Brake Emissions – Multi-filter holder device

Amendment 12.1.3.1(g)

PM-probes (lances) with downstream
3-path-multisampler (schematic)

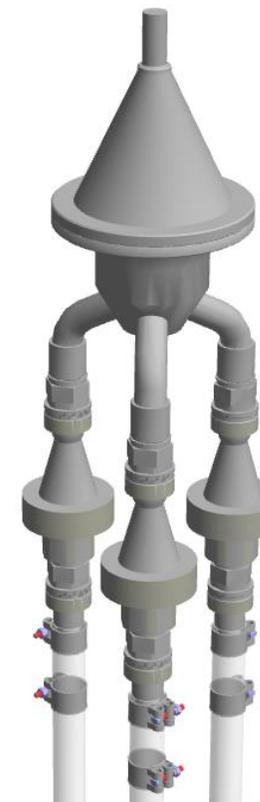
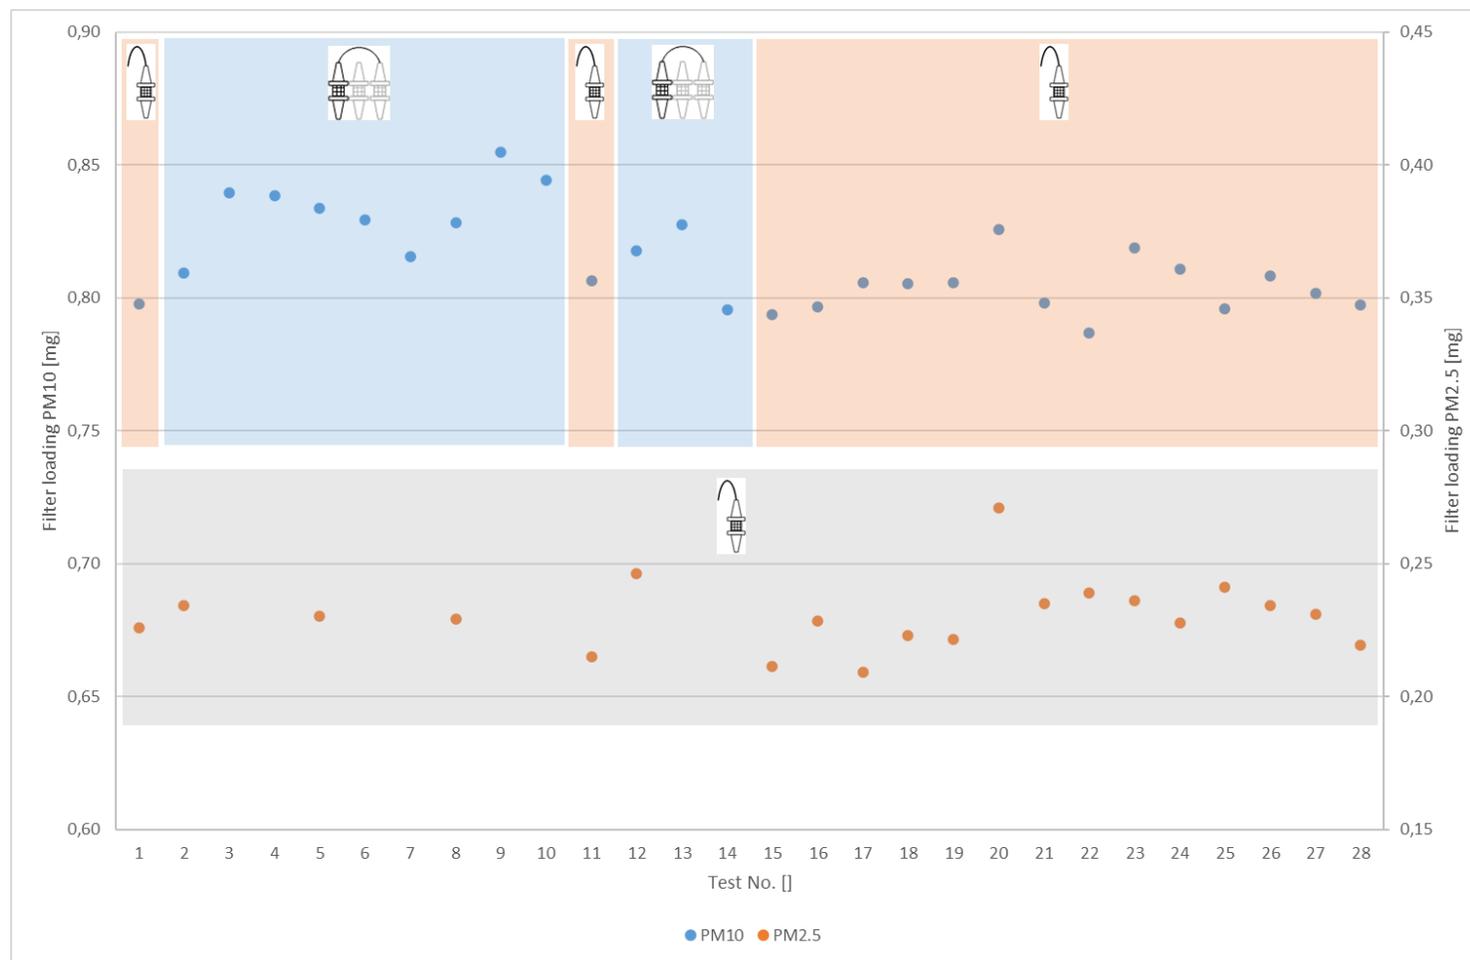
- Tests were conducted with an assembly from an exhaust test stand.
- Results so far do not confirm that a multisampler assembly as shown before is **not** proper to be used in the brake emissions area

=> is not reasonable against the background of the shown measurement results
